PHAP26-00002

Date: March 19, 2026
Application Type: Certificate of Appropriateness
Property Owner: Christine Ververis
Representative: HMR Windows
Legal Description: 19 Sunset Heights E 60 Ft Of 35 To 40 (9000.00 Sq Ft), City of El Paso, El Paso County, Texas
Historic District: Sunset Heights
Location: 1111 W. Yandell Drive
Representative District: #8
Existing Zoning: R-4/H (Residential/Historic)
Year Built: 1907
Historic Status: Landmark
Request: Certificate of Appropriateness for window installation
Orig. Application Filed: 2/5/2026
Orig. 45 Day Expiration: 3/22/2026

ITEM #1

Certificate of Appropriateness for window installation

PROPOSED WINDOW

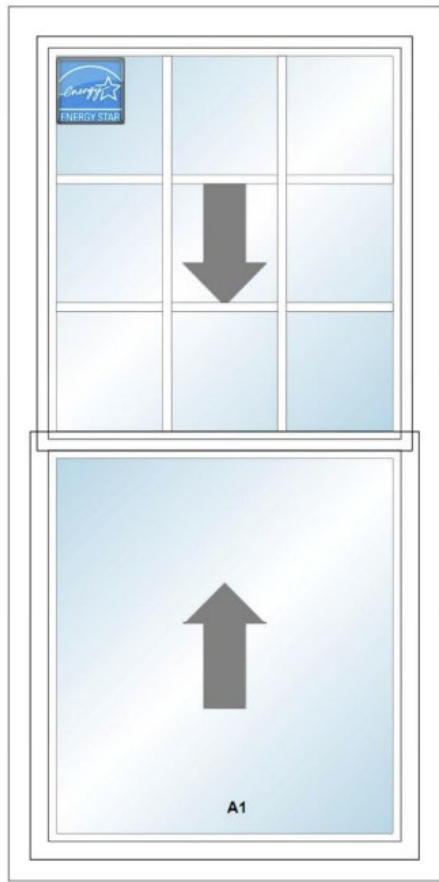
The Historic Preservation Office recommends APPROVAL WITH A MODIFICATION of the proposed scope of work based on the following recommendations:

The modification is that the window muntins be exterior applied and three-dimensional.
